Planning Observation

Reg. Ref. SD22A/0324

Hillhouse, Lucan Road, Lucan, Co. Dublin

South Dublin County Council

Figure 21.0 Site layout plan outlining the traffic calming measures proposed by the applicants.

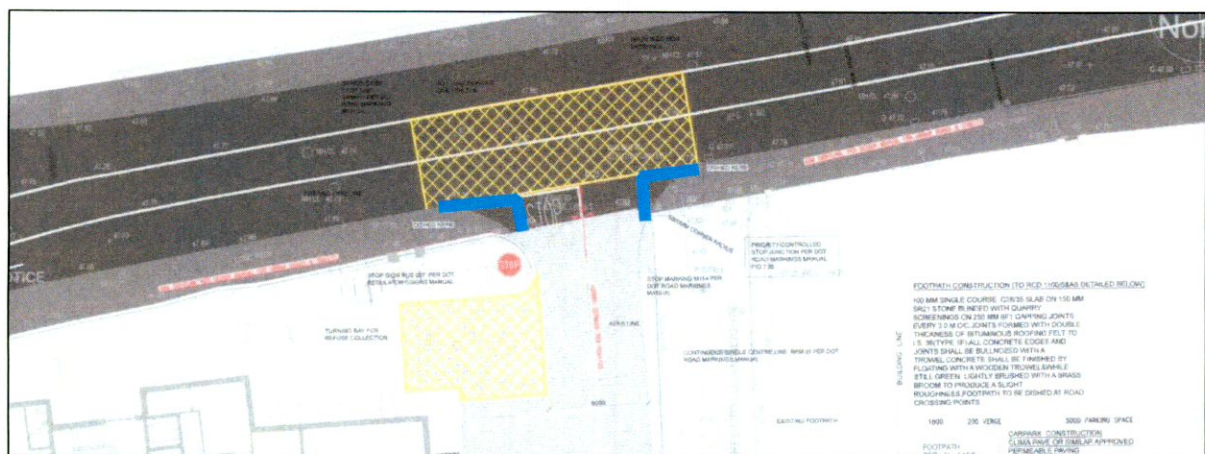
We consider that the angle of the proposed vehicular access to the site is too wide and as a result vehicles entering the site may not reduce their speed to a sufficient level in order to prevent traffic and

pedestrian incidents. A more angular junction, as shown with blue lines in Figure 21.0, would mitigate these concerns and result in a safer access to and from the site for vehicles and a more appropriate pedestrian crossing.

Figure 22.0 Proposed swept path analysis of the disabled car parking space.

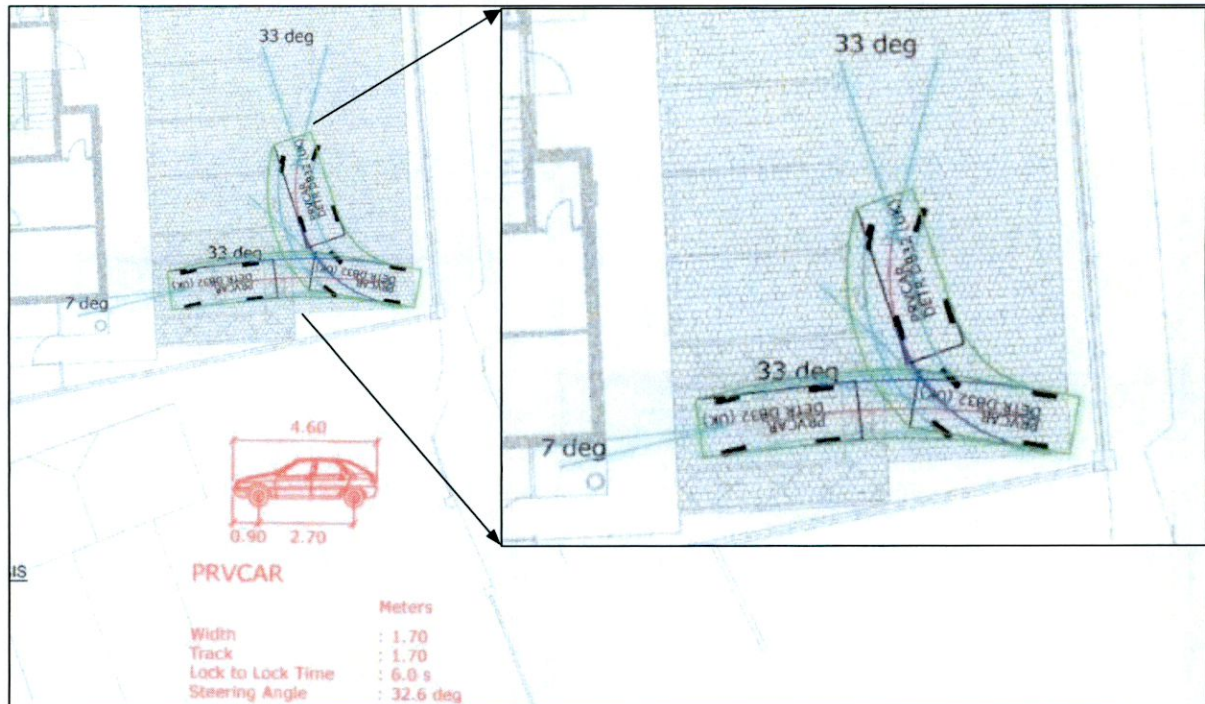
Furthermore, we contend that the proposed location and usability of the disabled parking space is not appropriate. The above drawing outlining the space required when a vehicle is making its turning manoeuvre out of the disabled space is unsuitable in its location and would increase the likelihood of collisions with the boundary wall and vehicles parked in the parking space to the north of the disabled parking space.

Figure 25.0 Extract from site layout plan, showing the close proximity of the bin to No. 4 Lucan Cloisters.

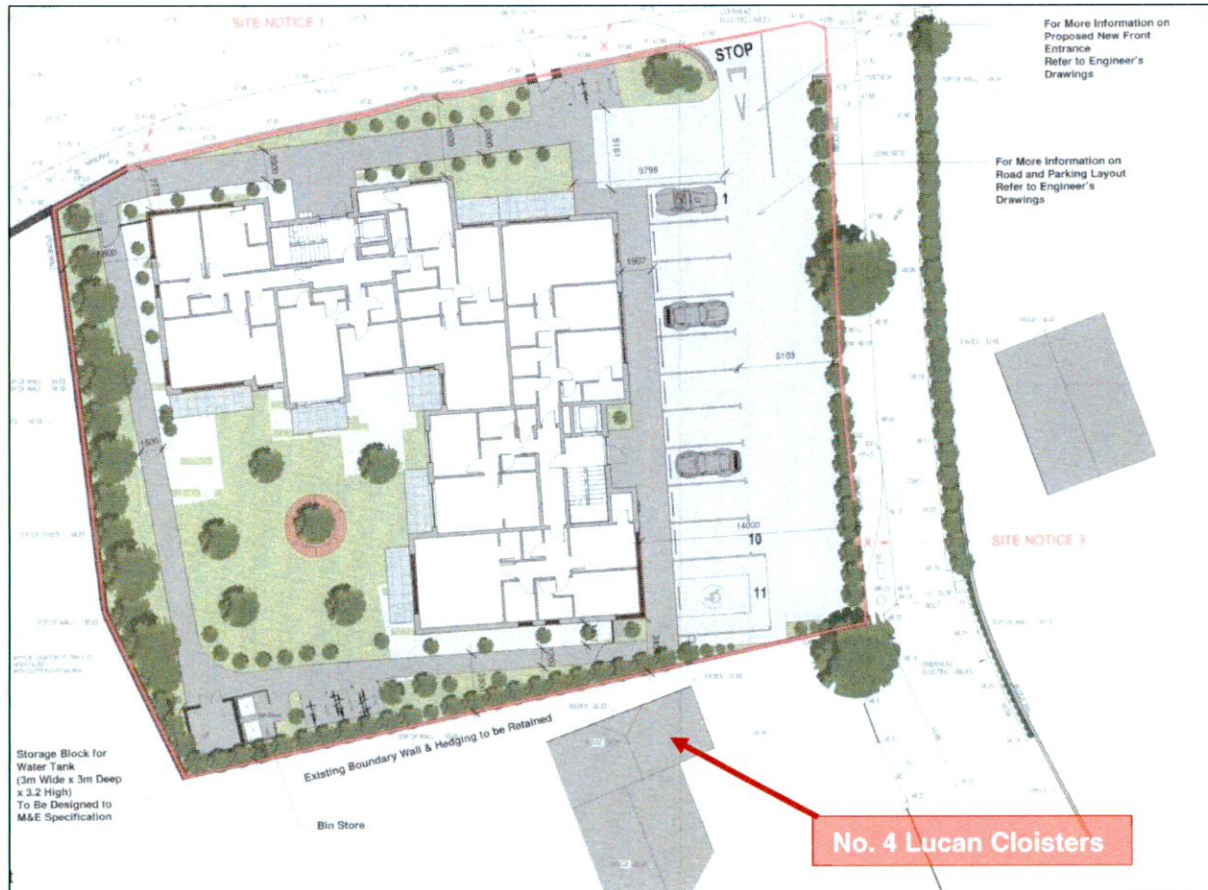
It is noted that the bin store is proposed to be located on the southern boundary, directly adjacent to the rear private amenity space of our clients' dwelling at No.4 Lucan Cloisters. This is considered completely unacceptable, as it would result in an odour on our clients' site. This would prove to be unsettling and possibly a risk to our clients' health over a prolonged period of exposure. Further, the location of the bins raises concerns regarding fly and pest infestations which may occur along the southern boundary. Given the proximity of the bin storage area to our clients' property, we view this as an additional risk to our clients' health. Moreover, residents at the proposed apartment units would have to wheel their bin to this location which would cause a lot of noise during all times of the day (and night). We also note the proximity of the water tank to the boundary walls which raises concerns relating to leakage and the impact on our clients' adjoining property to the south. Figure 24.0 below indicates the close proximity of the bin store and water tank to No. 4 Lucan Cloisters.
